Record of Decision
Operable Unit 1: Plant Site
Former Brooklyn Borough Gas Works Site
Coney Island, Kings County, New York
Site Number 2-24-026

March 2001

DECLARATION STATEMENT - RECORD OF DECISION

**Former Brooklyn Borough Gas Works Site
Operable Unit 1: Plant Site
Proposed Remedial Action Plan
Coney Island, Kings County, New York
Site No. 2-24-026**

Figure 5

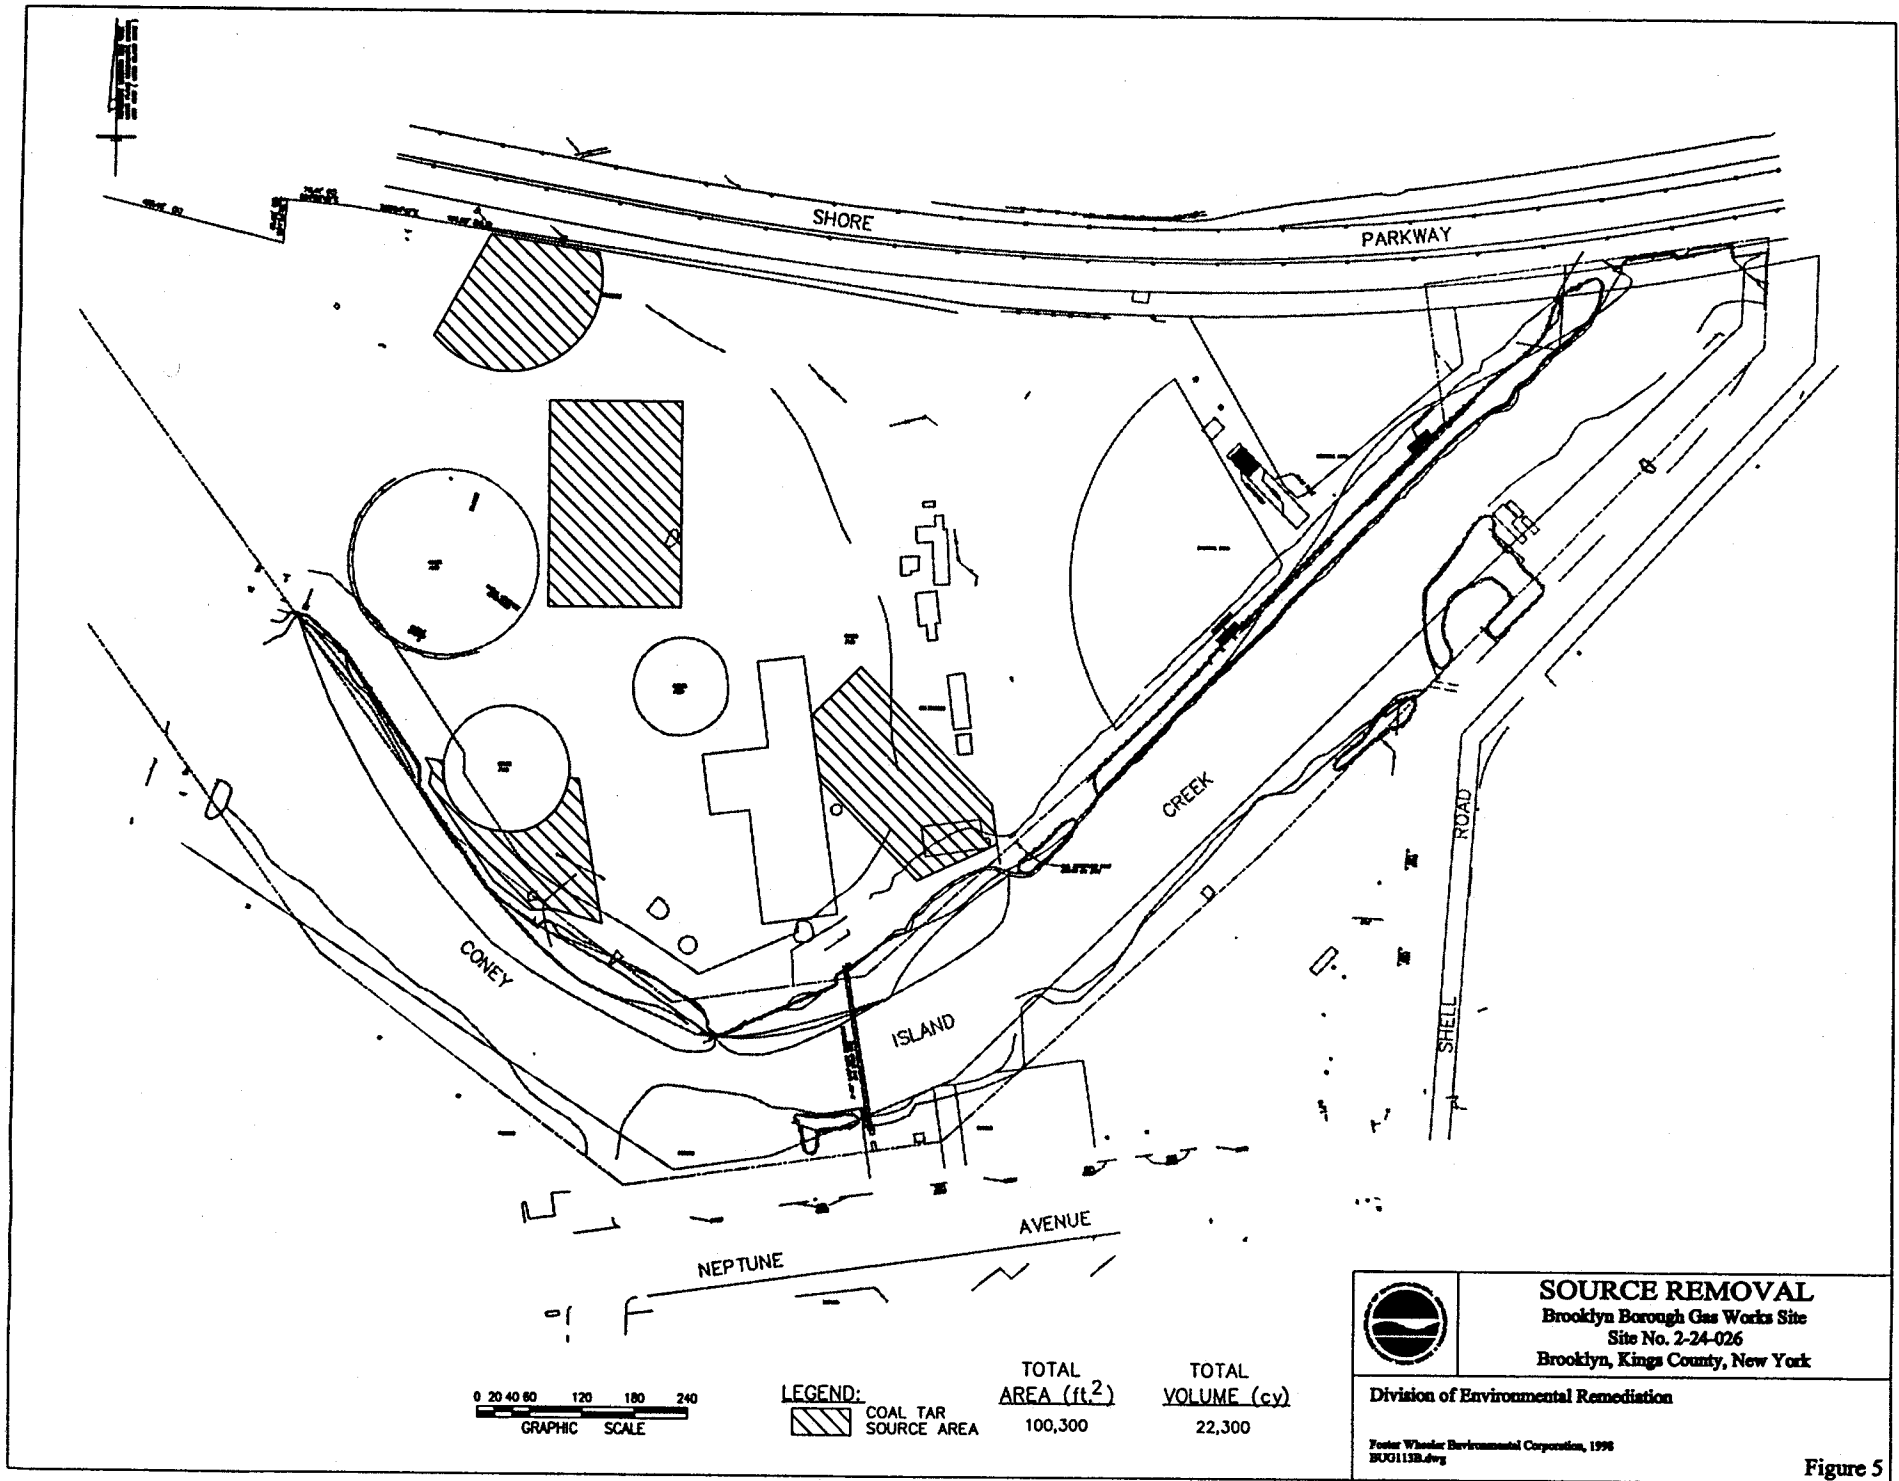
Comment 7: What about other areas on Figure 5 not being dug up? Is there light, medium, or heavy contamination?

Response 7: As stated earlier in Response 3, the nature of the contamination and the associated risks vary across the site and the remedy was selected to address these contaminants accordingly. The remedy selected for this site will 1) remove the mobile highly contaminated soils and waste (about 22,000 cubic yards), 2) eliminate or minimize exposure pathways by use of a cover system, 3) address residual contaminants remaining by collection and treatment of impacted groundwater and 4) prevent releases of contamination to the Coney Island Creek by the installation of a subsurface barrier wall around the entire 16 acre site.
